Access Compliance Report

Public Rights-of-Way

(Curb Ramps)

Intersection ID: 10017066	Main Street: NEAL_RD	Cross Street: N/A	Location: S
ADA ID: F1A52D235A37	Ramp Type: PerpDiag	Initial Pass/Fail: Fail	Overall Compliance: No
Severity Score: 22.5			
Codes/Mitigation Info/Possible Solution		Field Measurements/Component Compliance

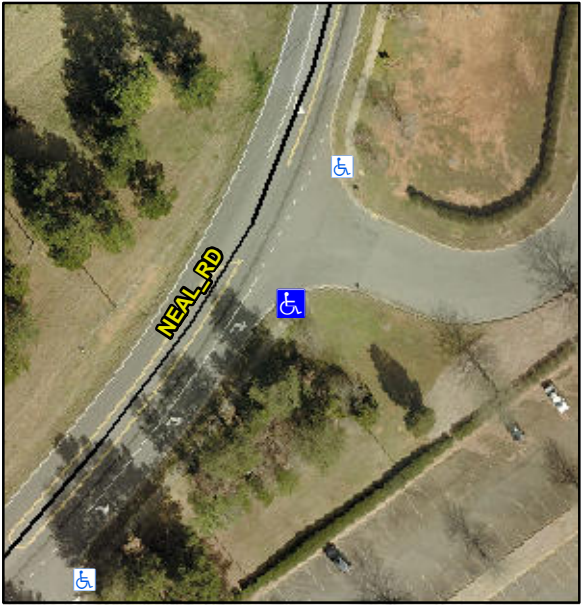
Possible Solutions:	Compliance	Description	Data	Compliance	Description	Data
	Remove & Replace Curb Ramp With Two New Directional Ramps or Equivalent.	N/A	Ramp Length (in)	80.0	No	Ramp Slope (%)	10.5
		No	Ramp Width (in)	47.0	Yes	Ramp XSlope (%)	4.4
		N/A	Flare Type LT	N/A	N/A	Flare Type RT	N/A
		N/A	Flare Slope LT (%)	N/A	N/A	Flare Slope RT (%)	N/A
		N/A	Flare Traversable LT?	N/A	N/A	Flare Traversable RT?	N/A
		N/A	Landing Length (in)	N/A	N/A	DWS Provided?	N/A
		N/A	Landing Width (in)	N/A	N/A	DWS Contrast?	N/A
		N/A	Landing Slope (%)	N/A	N/A	DWS Length (in)	N/A
		N/A	Landing X Slope (%)	N/A	N/A	DWS Full Width?	N/A
Surveyor Notes: N/A PROW/ADA: Not Found, R304.5.1, R304.2.2		N/A	Landing Curb? (Y/N)	N/A	N/A	DWS Offset (in)	N/A
		N/A	Shared Landing?	N/A			
		N/A	Gutter Ponding?	N/A	N/A	Gutter Slope (%)	N/A
		N/A	Gutter Lip Ht (in)	N/A	N/A	Gutter X Slope (%)	N/A
		N/A	Painted X Walk1?	No	N/A	Painted X Walk2?	No

X Walk 1 Direction	To NE		X Walk 2 Direction	To NW
		N/A	X Walk 1 Width (in)	N/A	N/A	X Walk 2 Width (in)	N/A
			X Walk 1 Slope (%)	3.2		X Walk 2 Slope (%)	11.9
			X Walk 1 X Slope (%)	7.4		X Walk 2 X Slope (%)	4.0
		N/A	Ramp inside XWalk1?	N/A	N/A	Ramp inside XWalk2?	N/A
Street 1 Name Stop Condition-Street 2 Street 2 Name Stop Condition-Street 1			Road Slope (%)	7.1	N/A	Clear Space?	N/A
			Road X Slope (%)	5.5	N/A	Clear Space to XWalk (in)	N/A
		N/A	Any Obstructions?	N/A	N/A	Storm Grate/Utility Hazard?	N/A
			Obstruction Type			Storm Grate/Utility Type	
				N/A			N/A
					Yes	Surface Condition? (G/P)	Good
Total Cost:		\$	3200.00
